Wisconsin Department of Transportation

Proposal #13: 2759-03-70, WISC 2020 074
North Avenue
N. Calhoun Road to E County Line
CTH M
Waukesha County

This is Addendum No. 01, which provides for the following:

Addendum No. 01
ID 2759-03-70
Revised Sheet 39
March 3, 2020

POND_OUTFALL_STRUCTURE_DETAIL

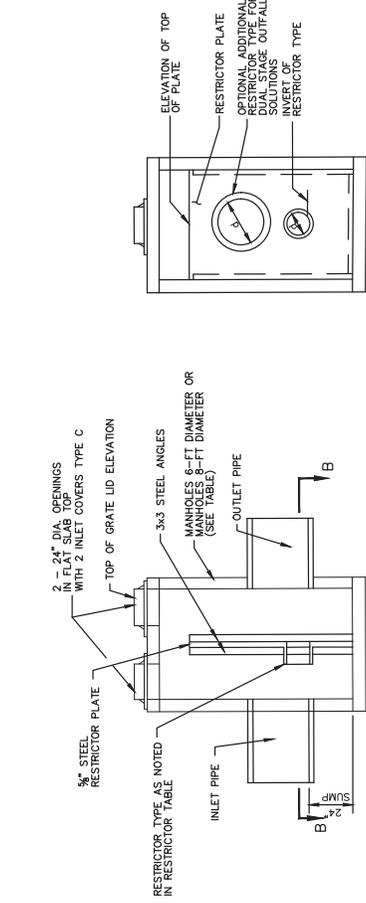
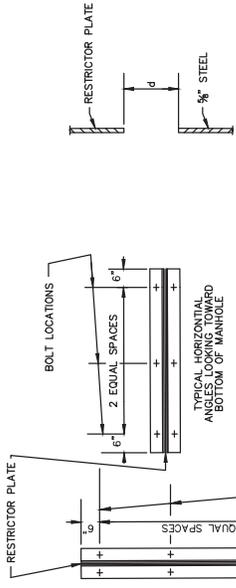
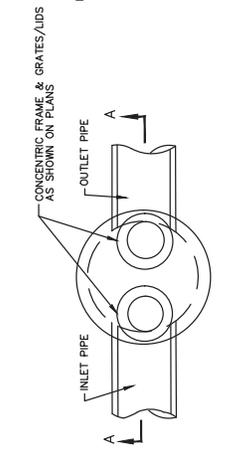
Revised Plan Sheets	
Plan Sheet	Plan Sheet Title (brief description of changes to sheet)
39	Pond Outfall Structure Detail (Revision to restrictor diameter and invert elevation)

STRUCTURE NUMBER	MANHOLE DIAMETER	FRAME AND GRATE	RESTRICTOR TYPE	RESTRICTOR DIAMETER in. (d)	INVERT OF RESTRICTOR TYPE	ELEVATION OF TOP OF PLATE OVERFLOW	TOP OF GRATE LID ELEVATION	100-YR WATER SURFACE ELEVATION
200.15	6'	SOLID LID	ORIFICE	2	819.50	824.20	825.20	824.30
204.02	6'	SOLID LID	ORIFICE	2	818.50	823.50	824.50	822.03
504.02	8'	SOLID LID	ORIFICE	2X32	754.10	758.60	759.60	759.00
